From: Marian Healy [mailto:MarianHealy@offalycoco.ie]
Sent: 20 May 2009 17:07
To: Breen Higgins
Subject: Derryclure Landfill WL 29-2

RESPONSE TO RFI – INTENSIFICATION OF WASTE INTAKE AT DERRYCLURE LANDFILL

OFFALY COUNTY COUNCIL

Abstract: This document forms the response to the request for further information from an Bord Pleanála in relation to application reference 19.JA0013.

Figure 3-1 (Figure 1-4 of EIS)

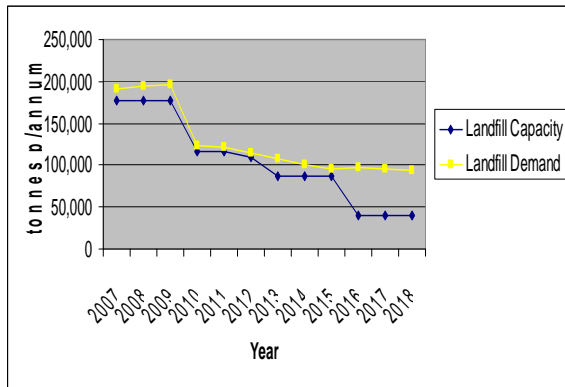
It is also stated in the Laois County Council submission that 'the licenced limits for the Region (177,000 tonnes in total) appears to be equated to Landfill Demand'.

- Figure 3-1 clearly displays a deficit of regional capacity in all years modelled based on current capacity, especially in the years beyond 2015, after which Kyletalesha could close (based on constructed capacity)
- This deficit is in the range of 15,000 to 20,000 tonnes between 2007 and 2010 and is approximately 5,000 tonnes between 2010 and 2013 – as stated previously, demand and capacity is likely to be greater between the first (2010) and second (2013) target years of the Landfill Directive. This is further evidenced by the data in Table 3-2.
- Figure 3-1 of the EIS describes the baseline situation of demand and capacity based on waste generation in the Midland region alone and does not take account of the highly likely acceptance of waste from outside the Midlands Region including the Greater Dublin and Connaught Regions and the requirement for a safety factor

TITLE
TYPICAL_CROSS_SECTION

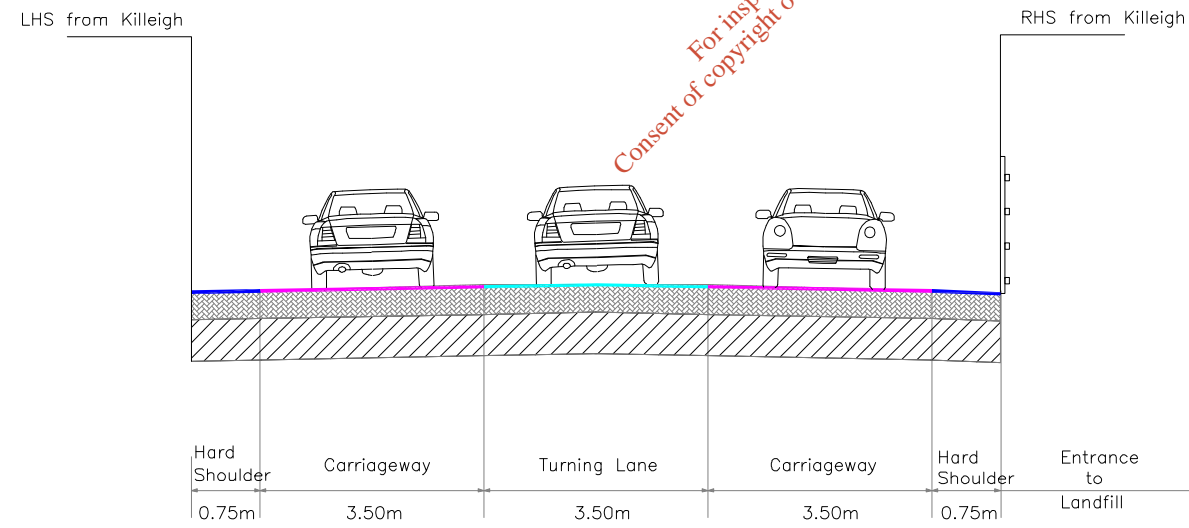
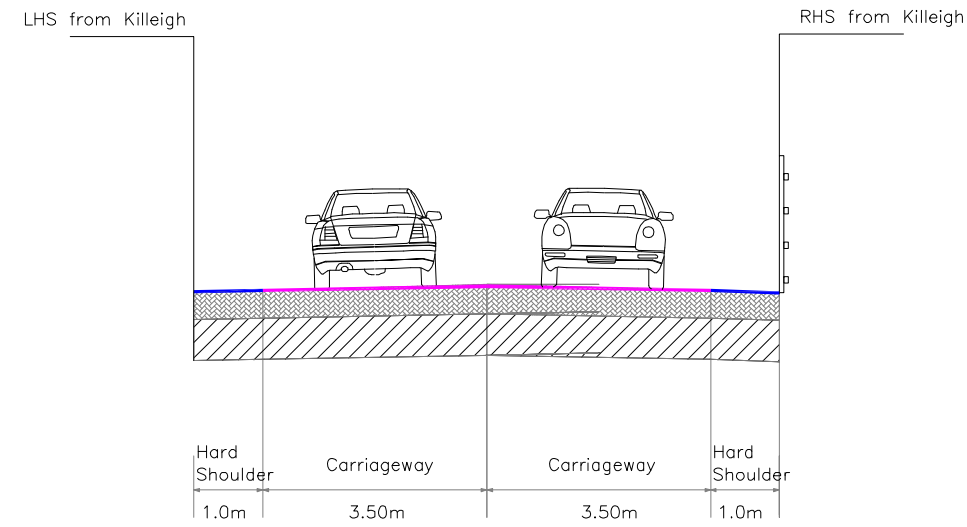
It is noted that the road alignment in drawing no. 012-005 is for a straight road. From site inspections and review of the other drawing, the proposed layout is on a large radius bend. Increased risk may occur if the junction is designed with the sightlines provided for a straight road, when in fact the junction is on the out side of a bend.
